Project	IEEE 802.16 Broadband Wireless Access Working Group < http://ieee802.org/16 >	
Title	Distinct OFDMA-based Ranging Code Sets for Relay Station and Mobile Station	
Date Submitted	2006-11-07	
Source(s)	<p>Kanchei (Ken) Loa, Yung-Ting Lee, Yi-Hsueh Tsai, Heng-Iang Hsu, Shiann-Tsong Sheu Institute for Information Industry 8F., No. 218, Sec. 2, Dunhua S. Rd., Taipei City, Taiwan.</p> <p>Hang Zhang, Mark Naden, Wen Tong, Peiying Zhu, Derek Yu David Steer, Gamini Senarath, G.Q. Wang Nortel 3500 Carling Avenue Ottawa, Ontario K2H 8E9</p>	<p>Voice: +886-2-2739-9616 Fax: +886-2-2378-2328 loa@nmi.iii.org.tw</p> <p>Voice: +1 613 7631315 WenTong@nortel.com</p>
Re:	IEEE 802.16j-06/027: "Call for Technical Proposals regarding IEEE Project P802.16j"	
Abstract	This document is to define distinct OFDMA-based ranging code sets for relay station and mobile station in IEEE 802.16j-06/026.	
Purpose	Adopt the text proposal in this document

Distinct OFDMA-based Ranging Code Sets for Relay Station and Mobile Station

Figure 1 Comparison between Original and Proposed Ranging Code Sets

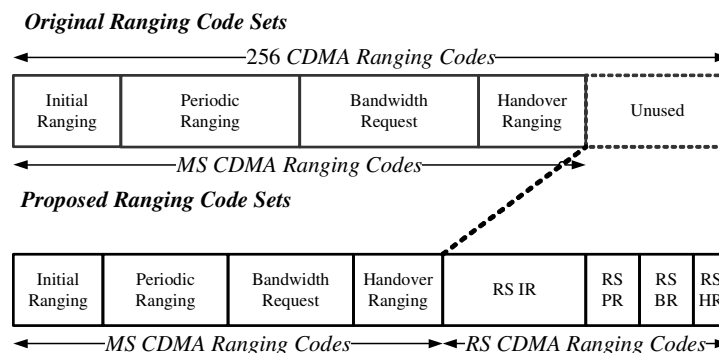
Four new ranging code sets, namely RS IR (Initial Ranging); RS PR (Periodic Ranging); RS BR (Bandwidth Request); RS HR (Handover Ranging) are defined for RS. The allocation of the eight ranging code sets is determined by MR-BS

Figure 2 RS cannot join a 2-hop MR network via RS

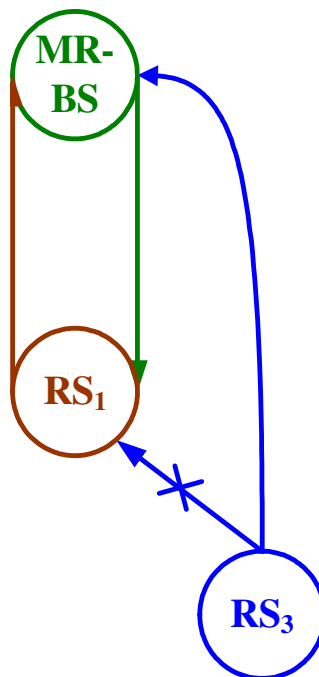
Figure 2 illustrates advantages of using RS Initial Ranging Code. RS3 cannot join the MR network via RS1 due to policy restrictions (hot count limit, RS limited capability, ... etc). There are two possible ways for RS3 joining the MR network shown in Figure 2. RS3 could ramp up its transmission power of initial ranging until MR-BS can decode the initial ranging message correctly, and alternatively RS1 could forward the initial ranging message to MR-BS and MR-BS tells RS3 how to adjust radio parameters so that the RS3 can do initial ranging with MR-BS directly.
